Critical Area Determination

Staff Report and Decision

| Project No: | CAO17-007 (SEP18-021) |
| Project Description: | Request for approval of a critical areas determination in order to modify a steep slope and to install a stormwater drainage system within and across a watercourse and watercourse buffer associated with construction of a new single family residence. |

SITE IMPROVEMENT PLAN
BARCELLO HOMES S.F.R.
4634 EAST MERCER WAY
BORDAN MAKSAMCHUK
P.O. BOX 1733
AUBURN, WA 98071

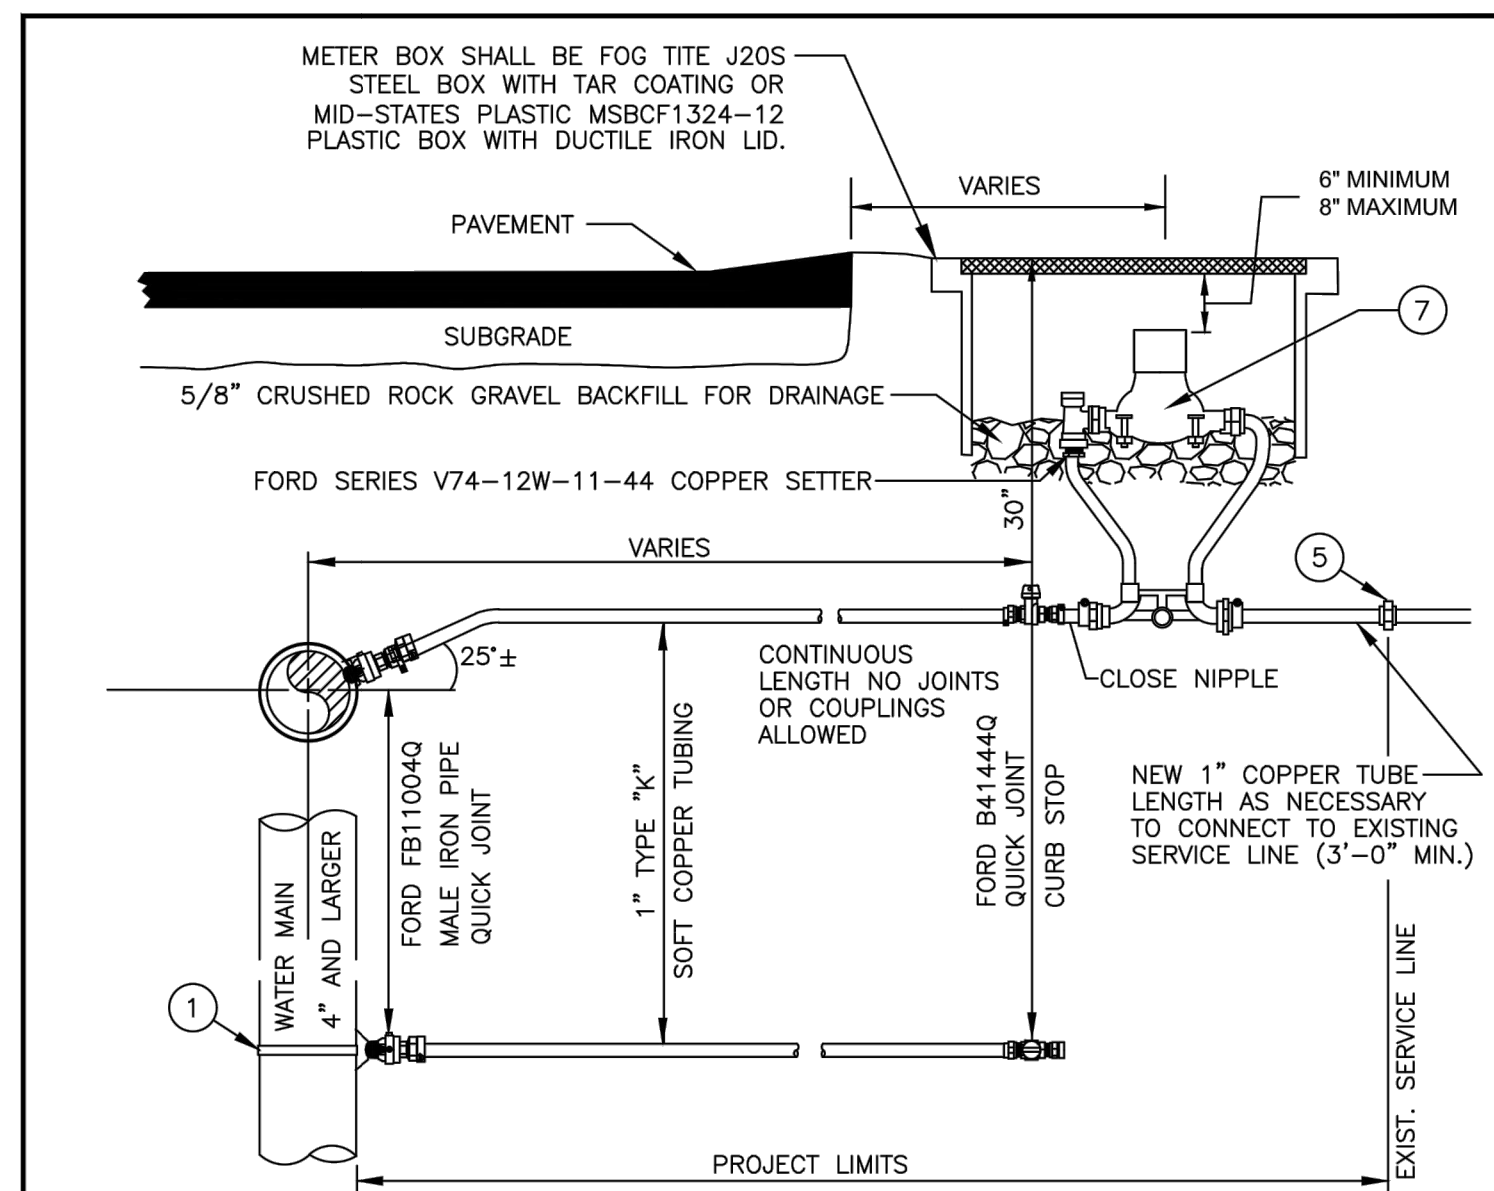
The civil drawing noted as Site Improvement Plan (Sheet 3 of 6) by Litchfield Engineering last revised 8/3/2018, has wall elevations contrary to the architectural and structural drawings.

This same plan (Sheet 3 of 6) indicates wall footing drains behind the soldier pile walls. This is not appropriate since the soldier pile walls do not have footings. However, capturing surface water runoff above walls should be considered and included in the final design drawings.

A-A EXCAVATION AT WEST WALL WITH SOLDIER PILES

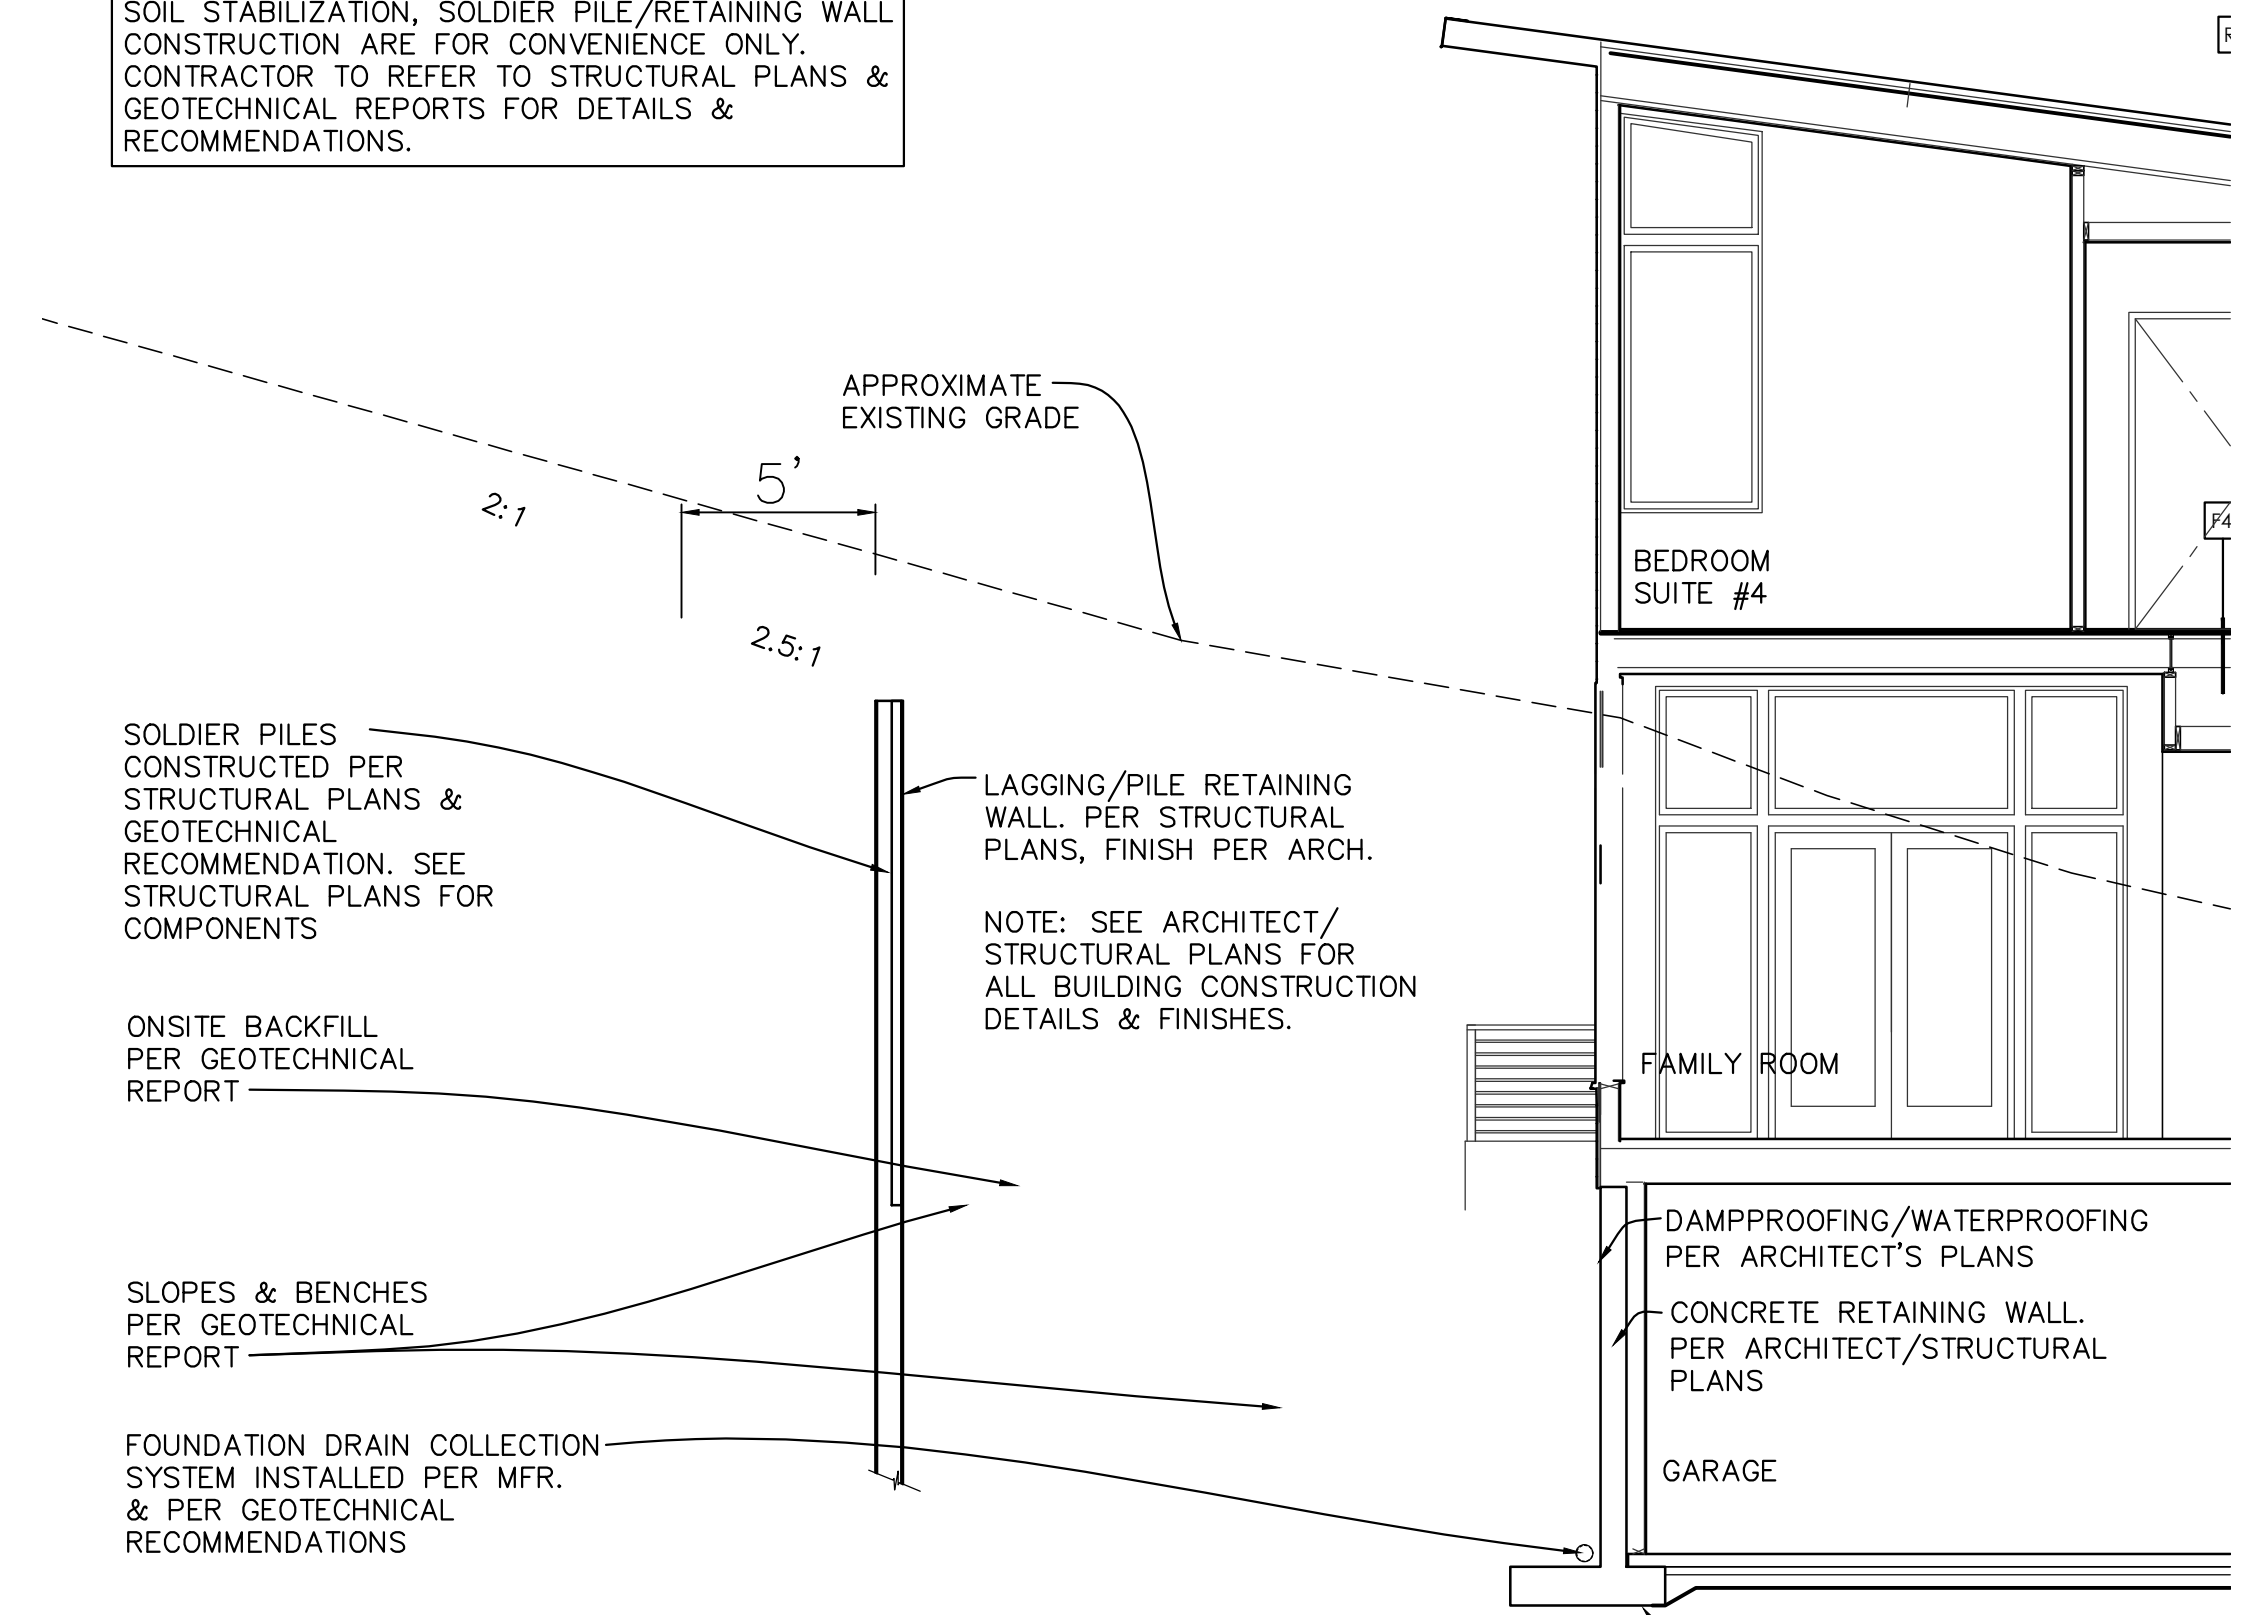
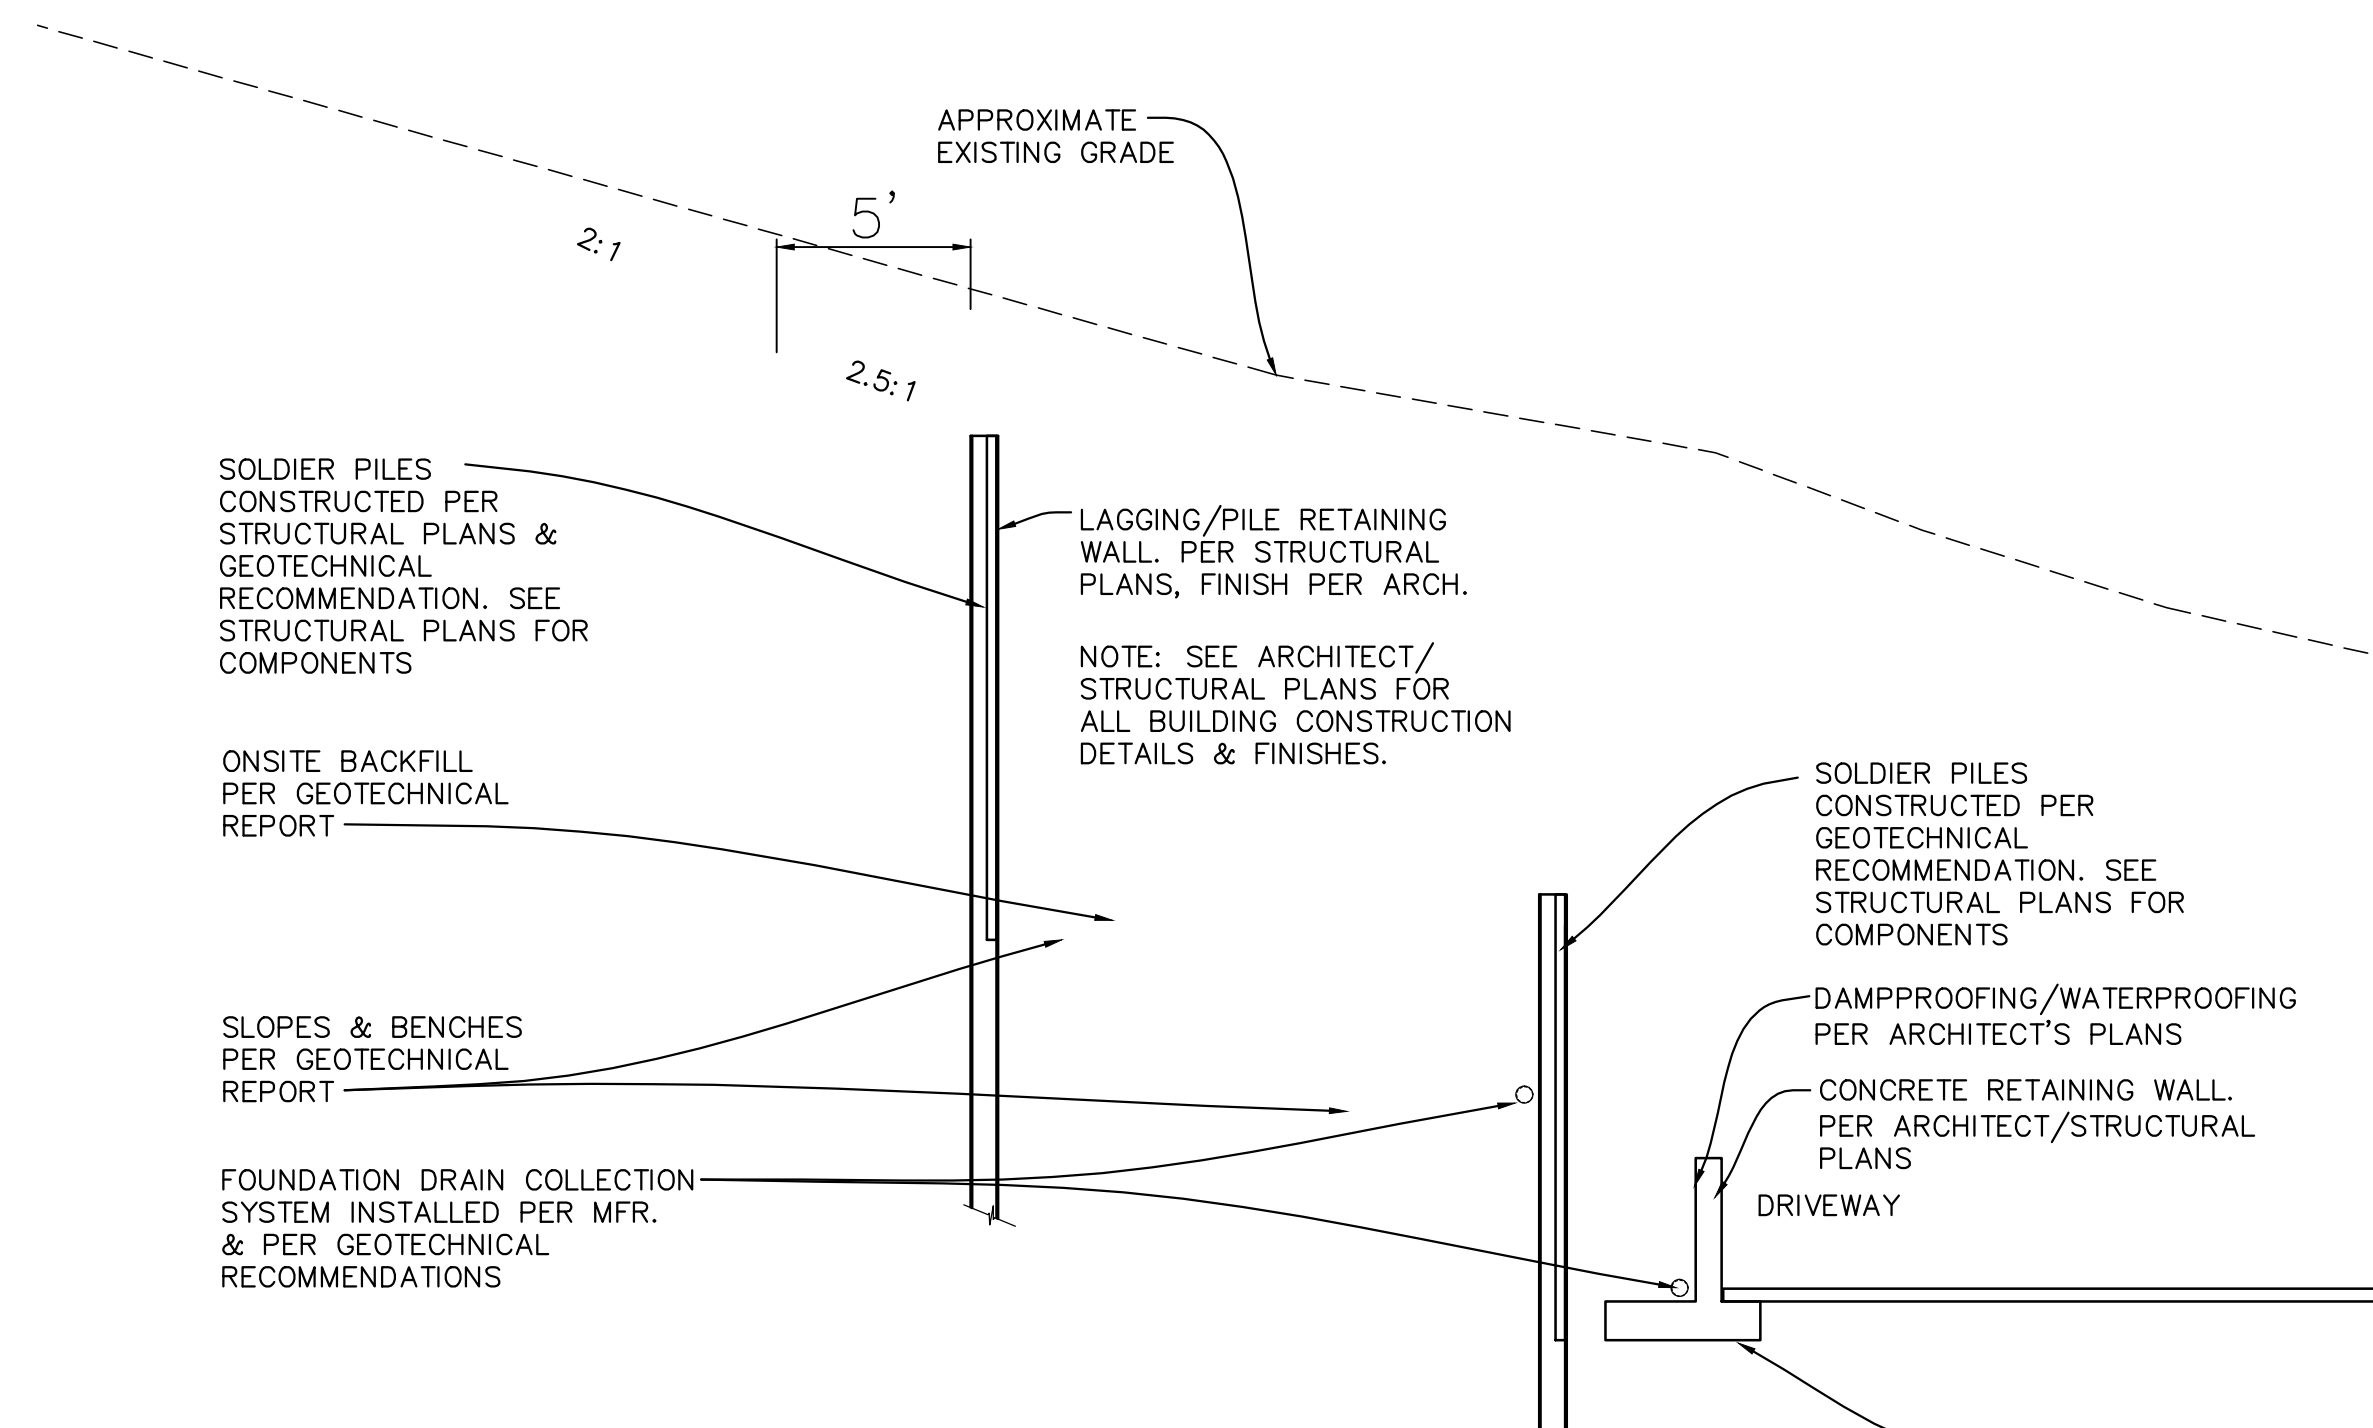
The temporary excavation plan on Sheet 5 of 6 by Litchfield Engineering last revised 8/3/2018, indicates a temporary 1H:1V cut in front of the soldier pile wall with a 5-foot wide bench in front of the wall. The structural drawing (S-11, by tecinstruct LLC, last revised 8/12/2016) does not indicate a bench. Whatever will be the worst-case condition (no bench) should be assessed for stability by the geotechnical engineer. If no bench is anticipated, the temporary excavation plan should also be revised.

Also, on Sheet 5 of 6 at the ends of the soldier pile wall, a permanent 1H:1V cut is indicated on the plans. The geotechnical engineer should provide specific permanent cut slope recommendations at these locations or the wall should be extended to reduce or eliminate the proposed cuts.
